工程變更客戶通知單

Engineering Change Customer Notification

ECR/ECN 單號： ECR/ECN Number:	EC-22-08-028
日期： Date:	2022/08/23
變更者/郵箱： Author/Mail	Ray Huang
客戶端工程變更需求確認：(signature) EC request confirmation by customer	請於 10 工作日內簽回，若超過 10 日未簽回將視為同意此變更 Please sign back within 10 working days, if you do not sign back within 10 working days, you will be deemed to agree to this change.
客戶端工程變更完成確認：(signature) EC completion confirmation by customer	請於 10 工作日內簽回，若超過 10 日未簽回將視為已確認 Please sign back within 10 working days. if you do not sign back within 10 working days, it will be deemed as confirmed.

產品類別 Product Category	零件編號 Part Number
	CAB.720/CAB.721/CAB.721.ky/CAB.738/CAB.739 /CAB.761/CAB.769.ky

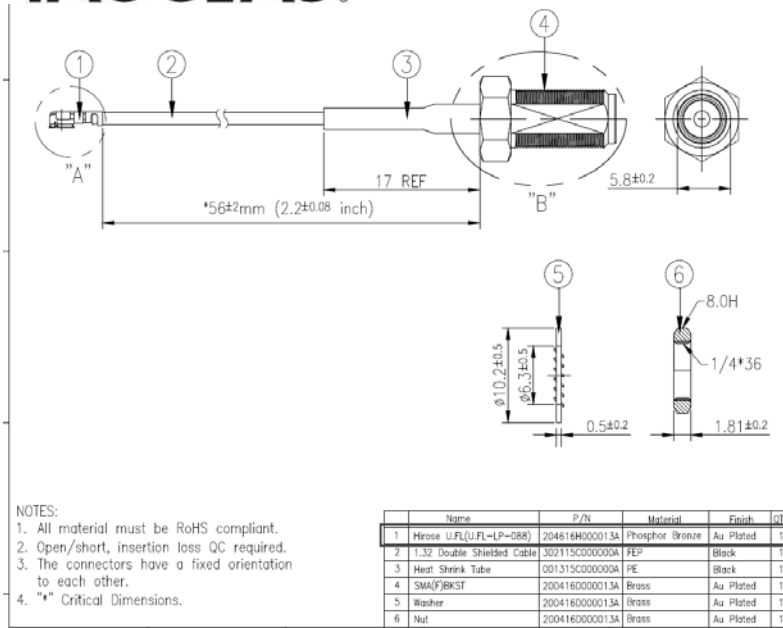
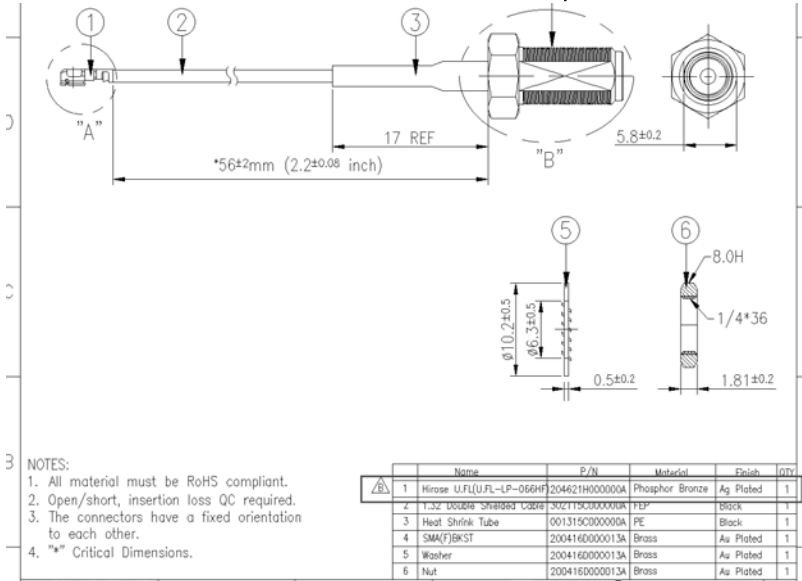
- The original connector of U.FL-LP(P)-088A is gold plated.

- The connector of U.FL-LP-066HF is silver plated.

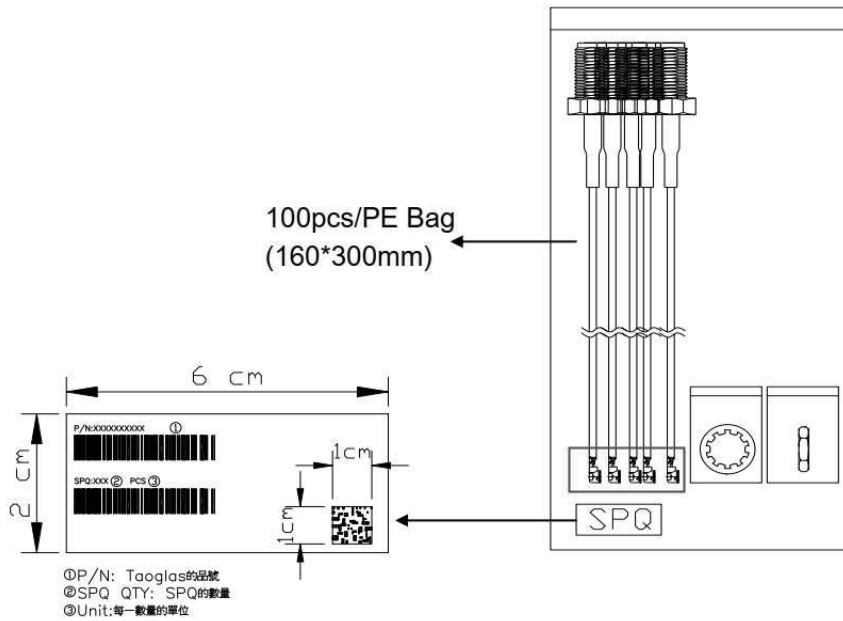
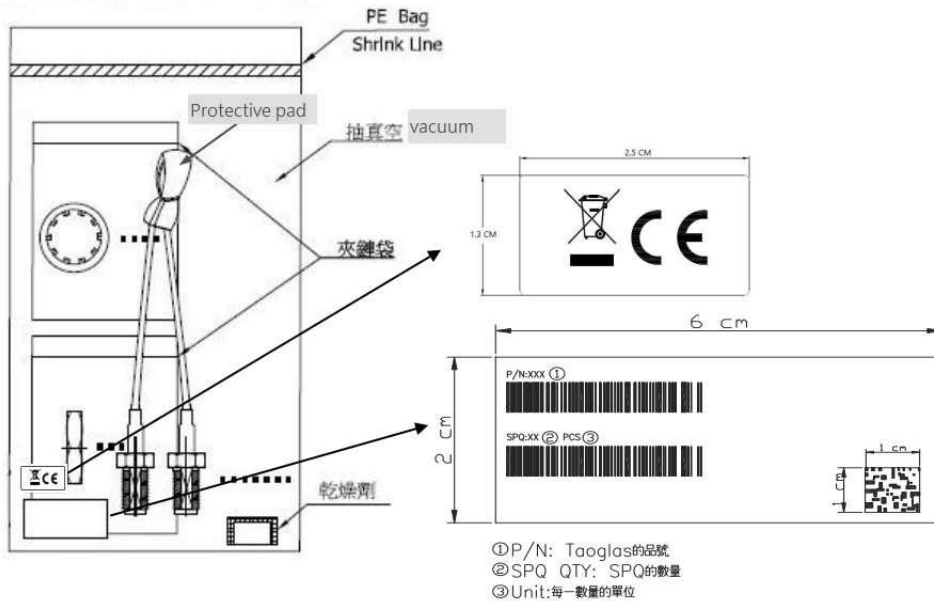
- The PE bag was not required vacuum and have protective pad wrapped around the connector to prevent Oxidation.

- The PE bag is required vacuum and have protective pad wrapped around the connector to prevent Oxidation.

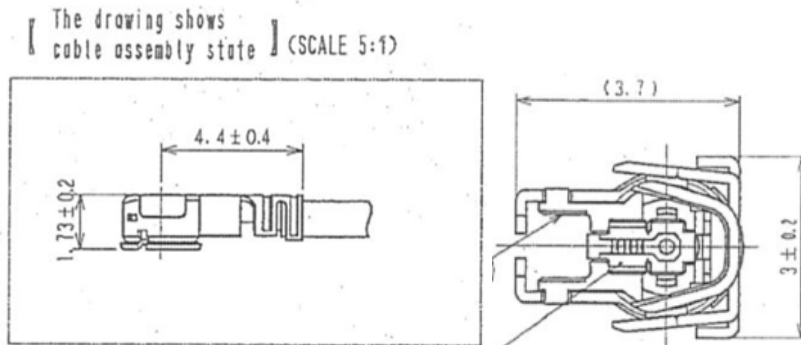
- Outside dimension of original connector.

- Outside dimension of new connector. The height is different from 1.73 mm to 1.93mm.
